Sunbeam Service Sheet No. 1

Subject: **To prevent breakage of the rear engine mounting damper plate (Model S.7)**

Date: **September 1948**

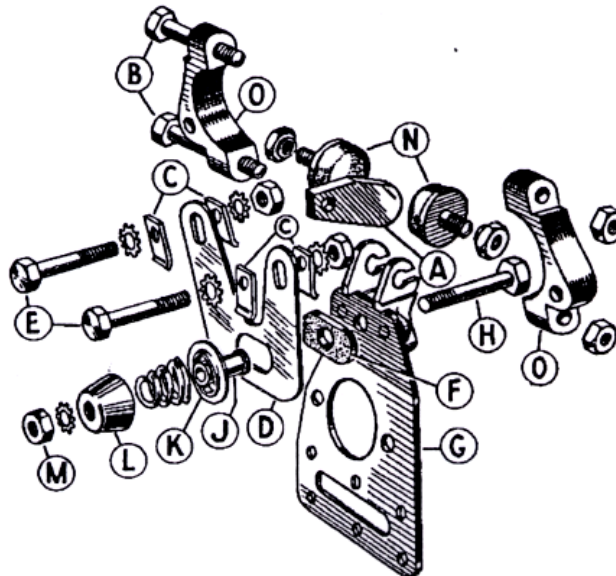
To obviate the possibility of the Engine Mounting Damper Plate breaking in the vicinity of the lug attachment bolts, reinforcement plates are fitted to all models after Engine Number S7-712. These plates have the effect of laminating the damper plate and should be fitted to all earlier models.

Remove the petrol tank and the plate attachment bolts **E** and replace the two distance pieces by the four reinforcement plates **C**, noting that these are fitted with the bevel away from the damper plate. Unscrew nut **M** and take off cap **L** and washer and spring **K**.

Slacken the nuts on the clip bracket and holding the friction disc **F** in position slide the bracket along the frame top tube until the damper plate just touches the friction disc.

Replace the bolt **H** and the distance piece **J** and position the damper plate **D** so that the distance piece is located centrally in the hole in the damper plate. Note that the bolt holes in the damper plate are elongated to allow movement. Refit the washer and spring **H**, cap **L**, and nut **M**, tightening the latter until the cap is locked against the distance piece **J**.

Tighten the nuts in the clip bracket starting with the lower nut to ensure that the tongue **A** is firmly held.

It is important that this procedure is followed carefully, particularly in connection with the positioning of the damper plate against the friction disc and the centralizing of the distance piece **J**. Incorrect assembly of the damper mechanism may result in fracturing of the damper plate.

After reassembly it is essential that the engine mounting is readjusted. Should it be necessary to move the clip bracket **O** to obtain correct clearance between the tongues **A** and the rubber buffers **N** the nuts on the bolts **E** should first be slackened so that the clearance of the distance piece in the hole in the damper plate is not affected.
